1.0 INTRODUCTION

2.0 FIELD INVESTIGATION

3.0 RESULTS OF INVESTIGATION

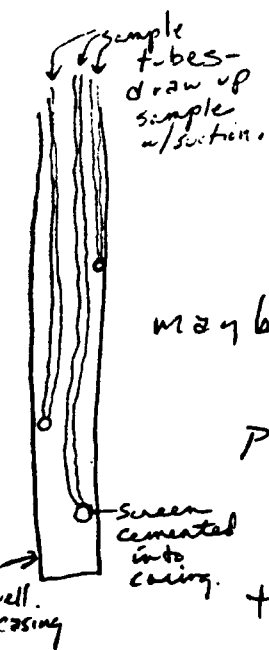
not of much value is a 2" well. with this type of well, you are probably measuring the k of the gravel/sand pack!

The only concern I have involves the use of the 1" ID Point-source bailers. Two problems come to mind in attempting to obtain an "undisturbed" sample using this method:

① If a multi-phase system exists, where oil is sitting on top of the saturated zone, the ^{interior of the} point-source bailer must be exposed to the oil layer. This will likely result in the transport of oily material down to the lower sampling interval, ~~thus~~ maybe producing artificially high contamination levels in the lower sample. This problem could be partially eliminated by use of a syringe-type sampler. Best method is to install multi-point piezometers built into casing (see drawing).

② After making the first trip into the well with the bailer, the ^{rest of the} water column will likely be disturbed in the well anyway due to the piston-effect of the 1" bailer in the 2" ID borehole.

These concerns may have an effect on any attempt to define vertical stratification of contaminants, I would tend to discount any conclusions in this area.
